Technical News Bulletin

Steinhausen, August 2015

Constant Cushion Blowhead, 210-1533

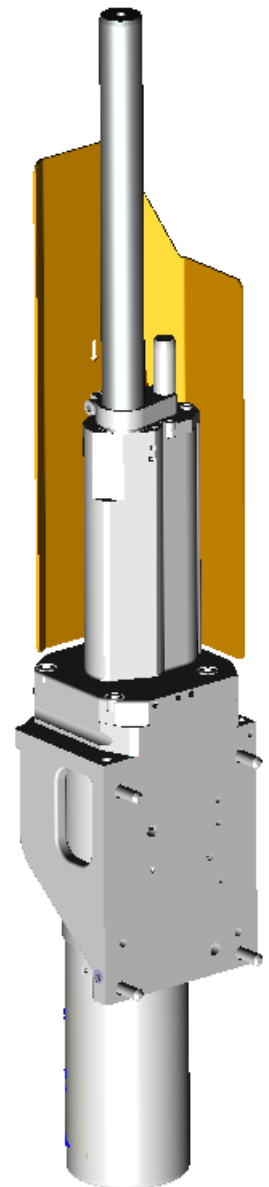
- Longer cooling tubes and improved internal container cooling enables increased blow mold contact time and higher machine performance.
- Improved motion cushioning for increased lifetime.
- Exchangeable oil cushioned cartridge without removing mechanism.

Faster machine speeds, heavier Blowhead arms and requirement for longer cooling tubes has drove the development to introduce the large CC Blowhead mechanism. Longer cooling tubes and improved internal container cooling enables increased blow mold contact time and higher machine performance. It uses oil cushioning for the up-stroke and can be retrofit for all large Emhart machines.
